**RE: Albuquerque RV & Boat Storage
2201 Vista Oriente St. NW
Grading and Drainage Plan
Engineer's Stamp Date: 06/18/19
Hydrology File: H10D030**

Based upon the information provided in your submittal received 06/18/2019, the Grading and Drainage Plan is approved for Building Permit and SO-19 Permit.

RE: Albuquerque RV & BOAT Storage (H09D030)

Attached with this letter are two sets of the revised Grading & Drainage plans for the above referenced project. Revisions made are in response to your review comments dated May 30, 2019 as follows:

**CG-101**  
SH. OF

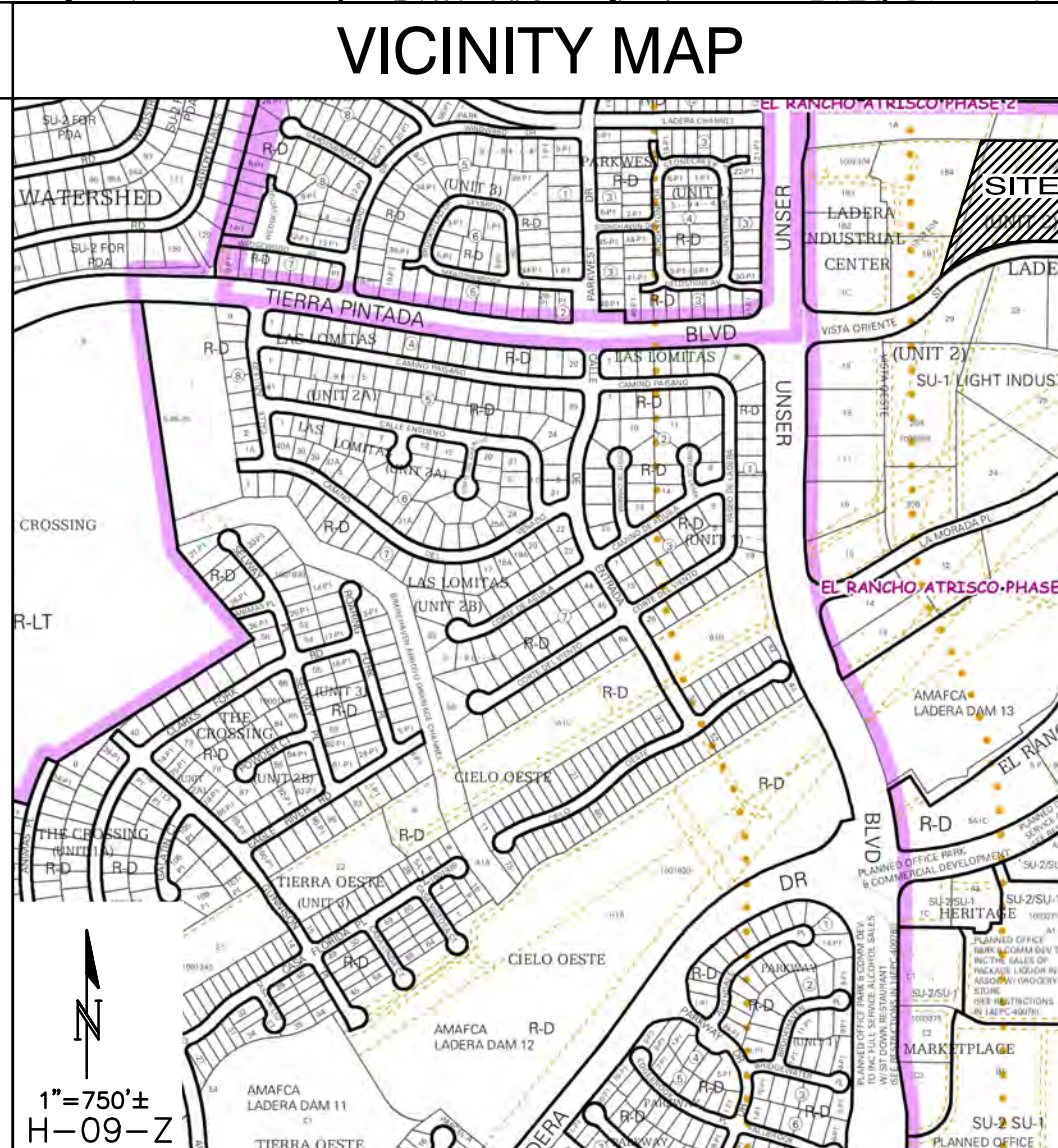
2. Reference to CABQ standard detail 2236 for sidewalk culverts has been added.
3. CG-101 border placement has been corrected.
4. Note Added "TOTAL SITE STORMWATER QUALITY POND VOLUME REQUIRED = 5,747 CF. TOTAL STORMWATER QUALITY POND VOLUME PROVIDED = 6,502 CF.

## STORMWATER OUTFALL STRUCTURE TO VISTA ORIENTE

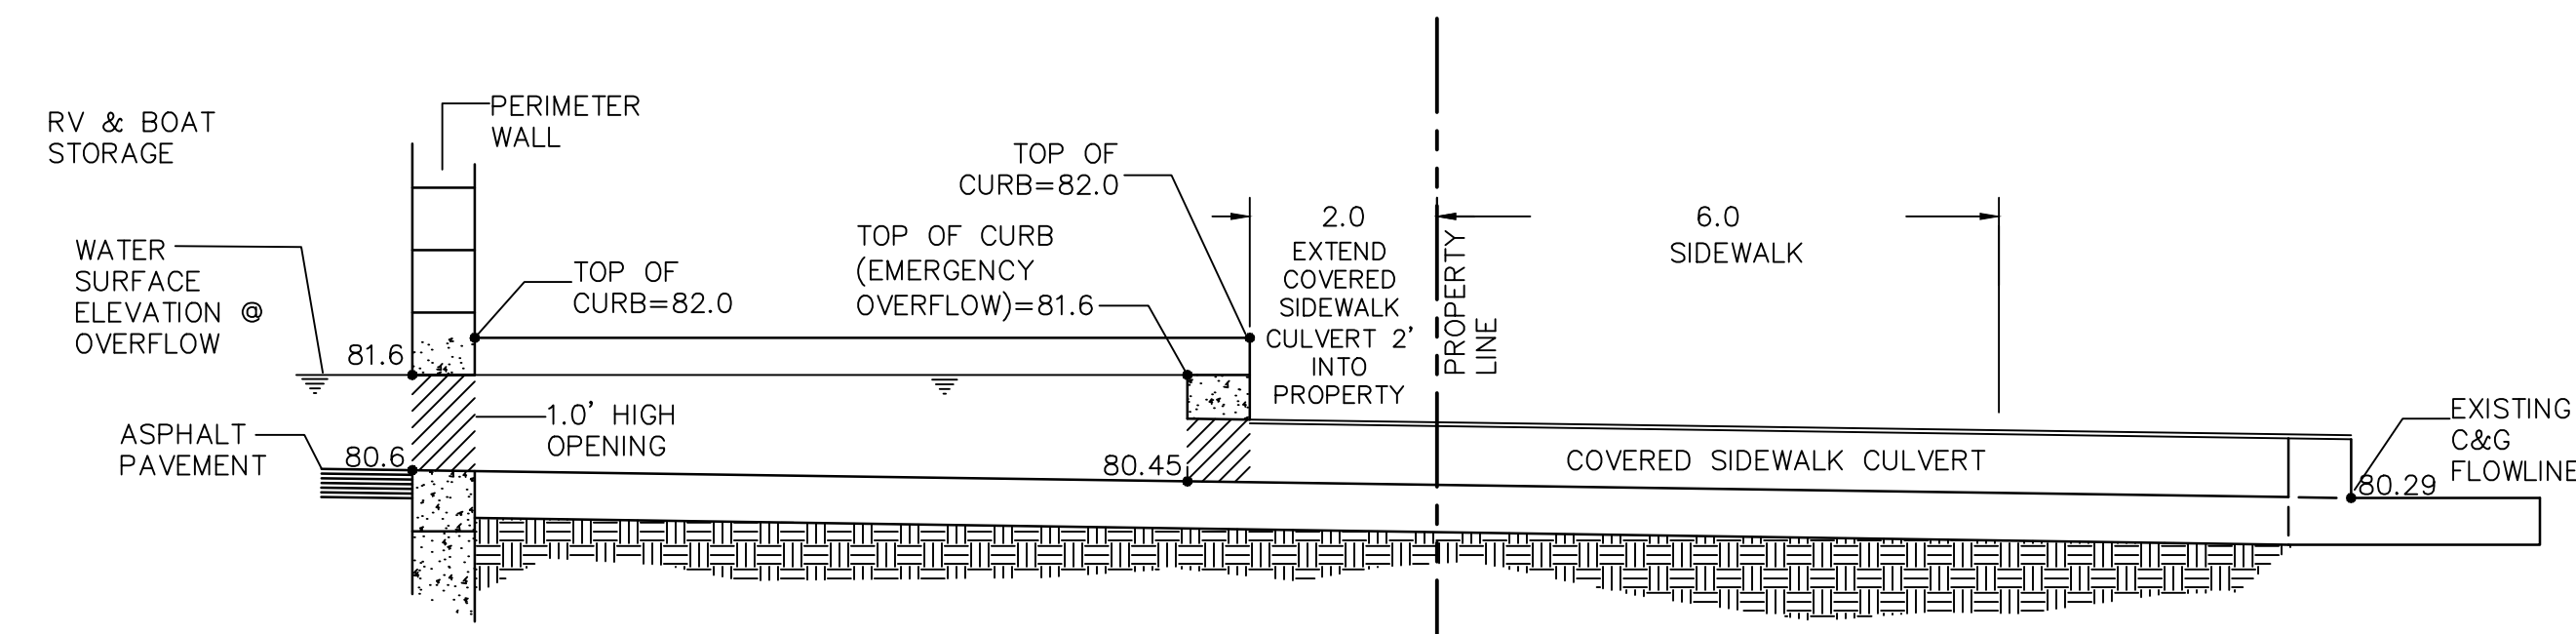
5. The outfall structure has been modified to control discharge with four 2' wide covered sidewalk culverts. The water surface elevation at the top of curb (emergency overflow) = 81.6. Orifice calculations for are provided on Sheet CG-502. Note: The opening through the site perimeter wall is redefined as three 4' wide x 1' high.

ORIFICE EQUATION - 2' WIDE CURB OPENING			
The Orifice Equation is used to calculate the Flow at the opening of a Channel			
$Q = C^*A * (2*g*h)^{.5}$			
Where	Q =	2.71	cfs
	C =	0.6	
	A =	1.125	sq.ft.
	g =	32.2	ft/sec ²
	h =	0.25	ft
depth of flow at opening from the center of culvert

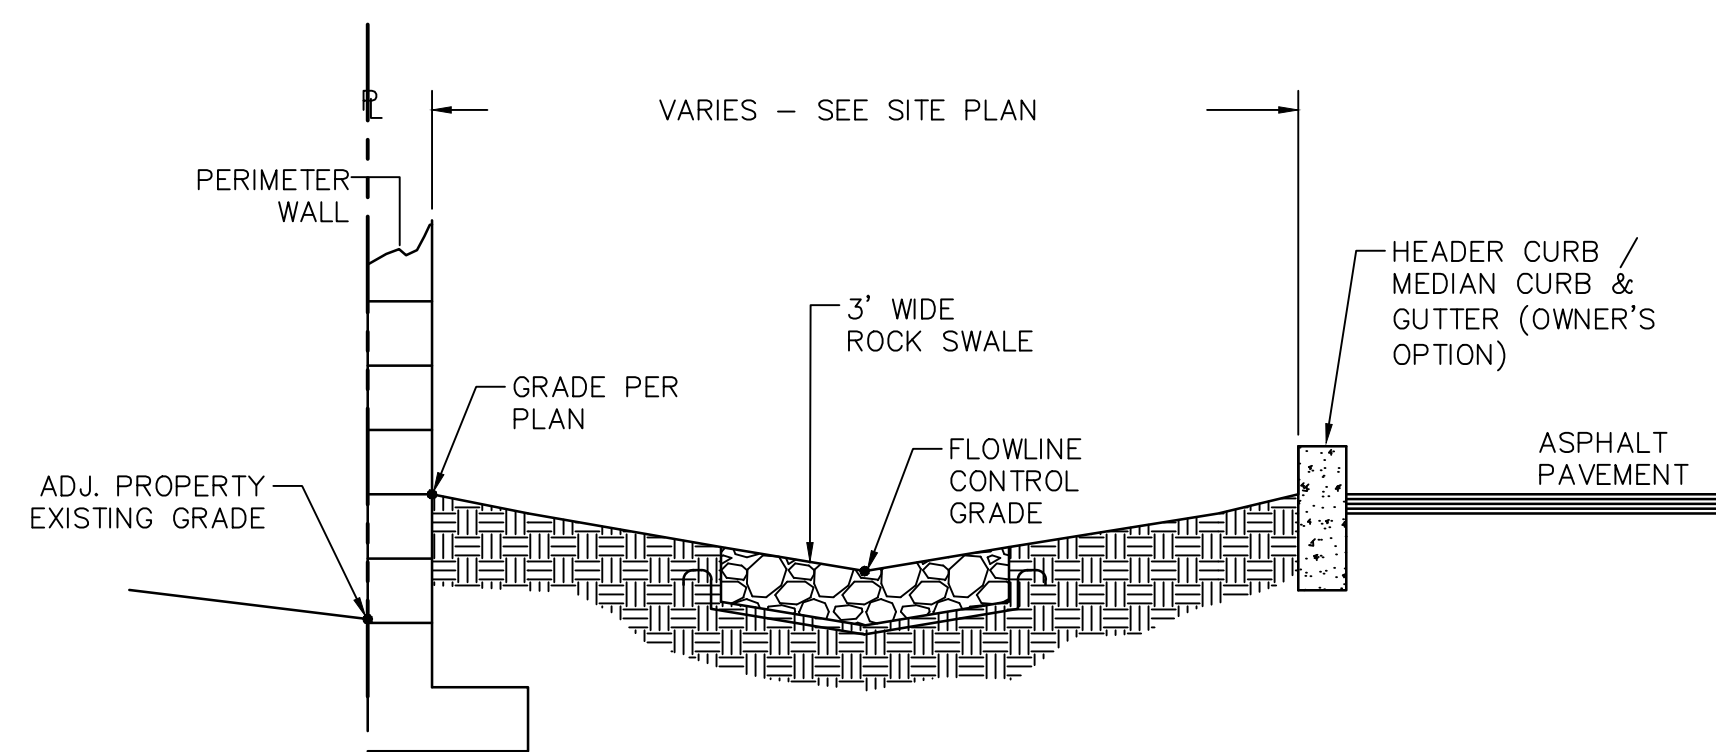
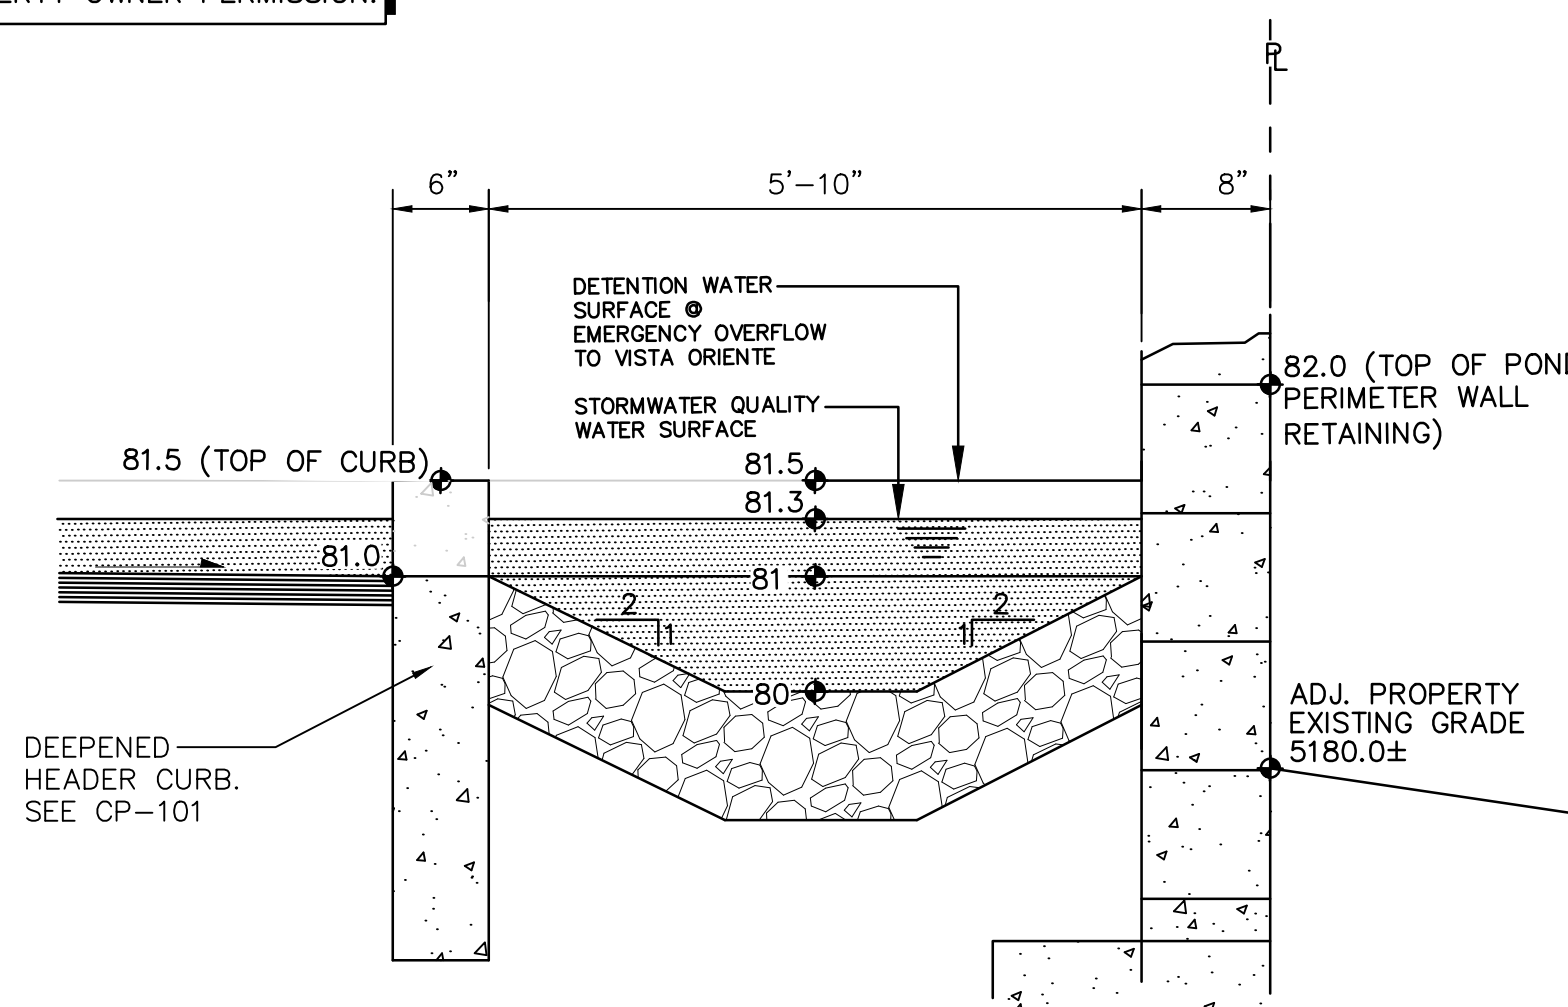
1. Sections through the proposed perimeter wall on the west and north property lines are provided. Per your request, the sections include the proposed perimeter wall, gravel swale, location of the wall 'L' footer and the proposed grades.

## WEIR CALCULATIONS

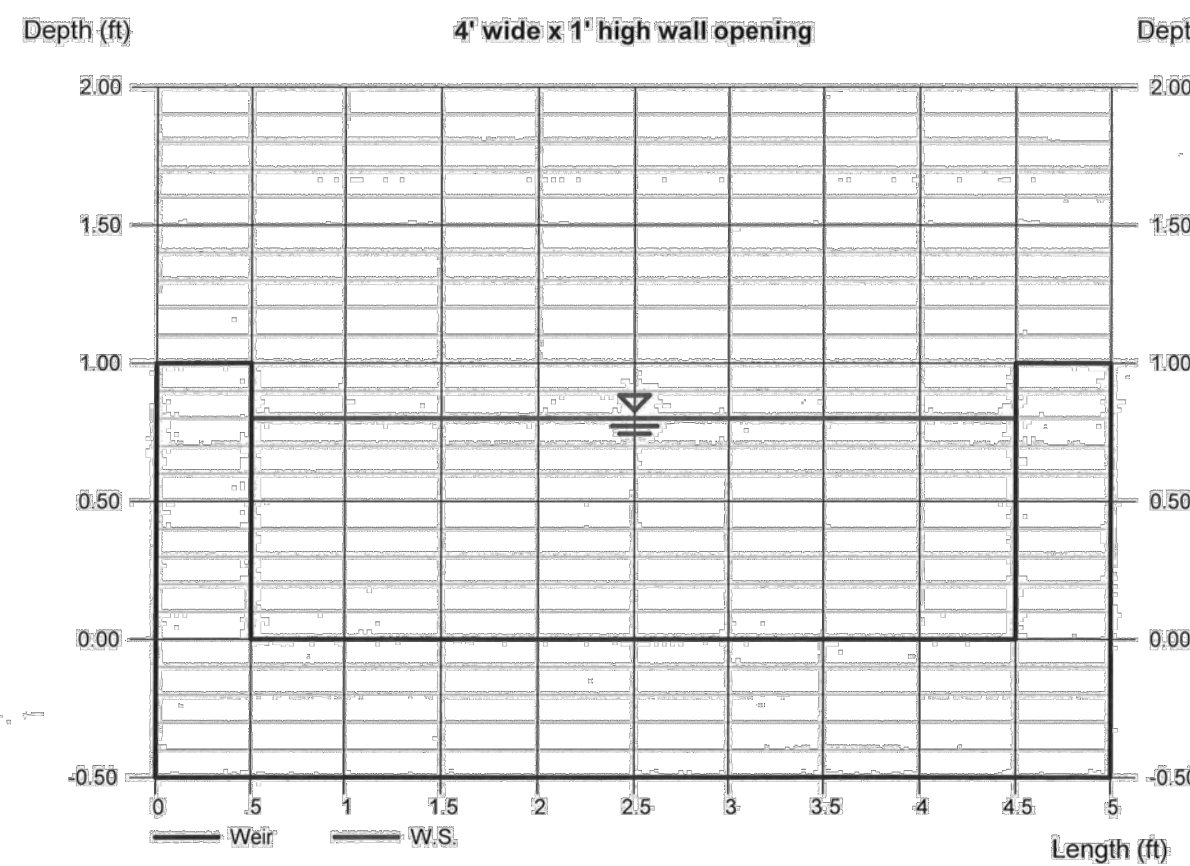
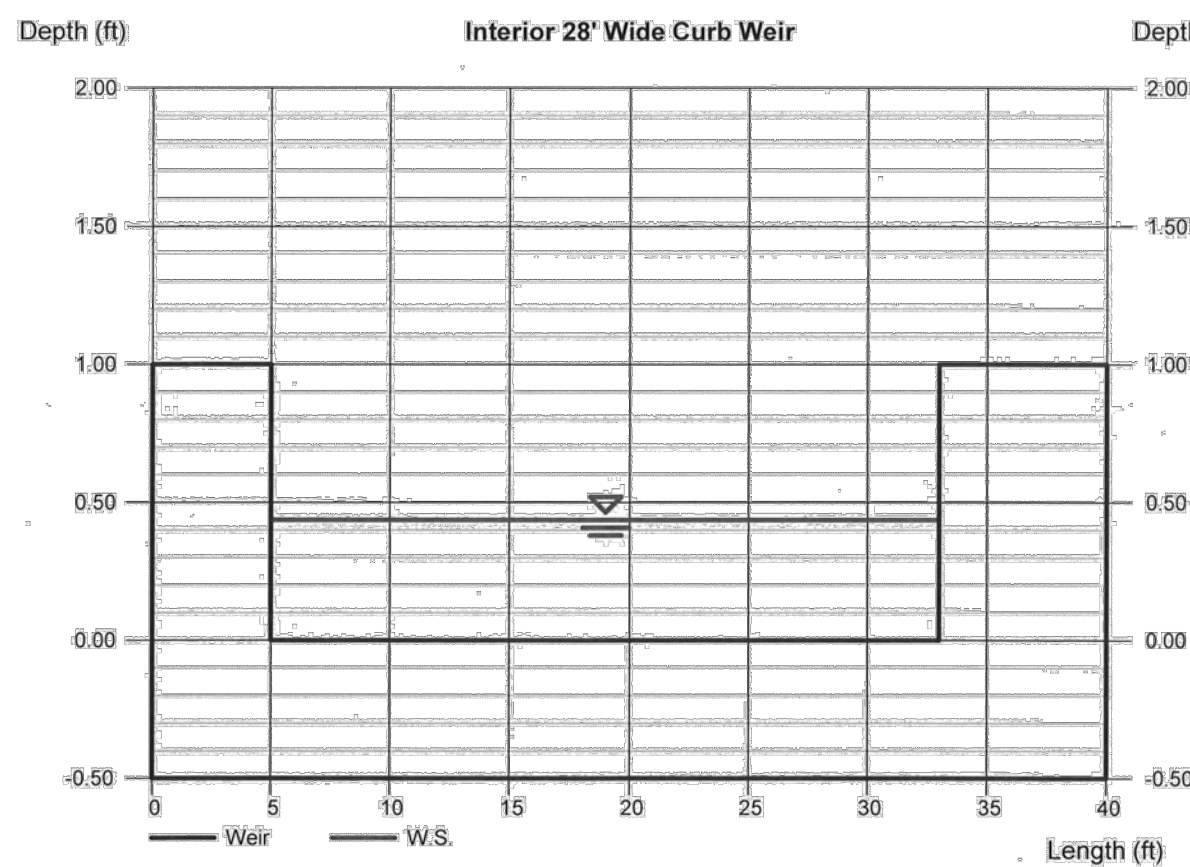
6. See weir calculations on Sheet CG-502.
7. Our client has been informed that because the project total area of disturbance (including the staging area and any work within the adjacent Right-of-Way) is 1 acre or more, an Erosion and Sediment Control (ESC) Plan and Owner's certified Notice of Intent (NOI) is required to be submitted to the Stormwater Quality Engineer (Curtis Cherne, PE, ccherne@cabq.gov, 924-3420) 14 days prior to any earth disturbance.

THREE 4' WIDE X 1.0' HIGH OPENINGS IN WALL. SEE ARCHITECTURAL FOR WALL DETAILS. AT 0.8' DEEP, CAPACITY = 7.4 CFS. THREE @ 7.4 = 22.2 > REQUIRED

TOP OF 28' OVERFLOW WEIR ELEVATION = 81.3. AT 81.4, ADDITIONAL FLOW WILL BYPASS THE STORMWATER QUALITY PONDING AND DISCHARGE DIRECTLY.
